REASONS FOR REISSUE

Fig. 40 - BW6A Terminal Strips - Mounted at Top of Frame - Switchboard Cable on Front - AMA Recorder Frames

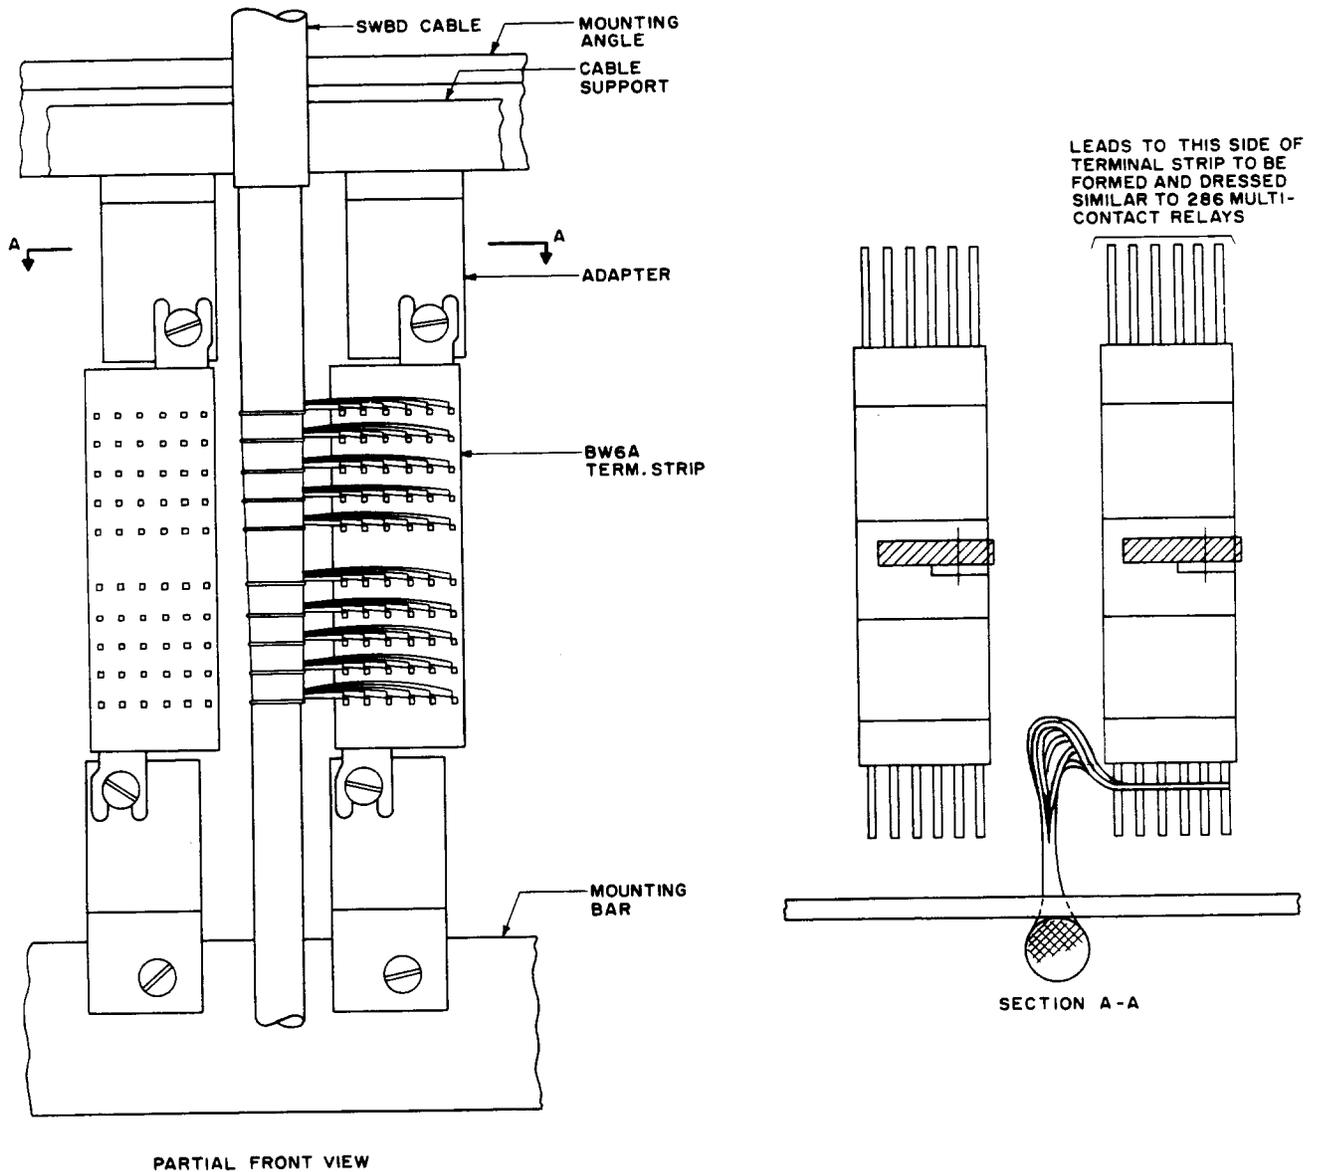
22. Fig. 40 covering BW6A terminal strips is revised to show a new method of lead dress.
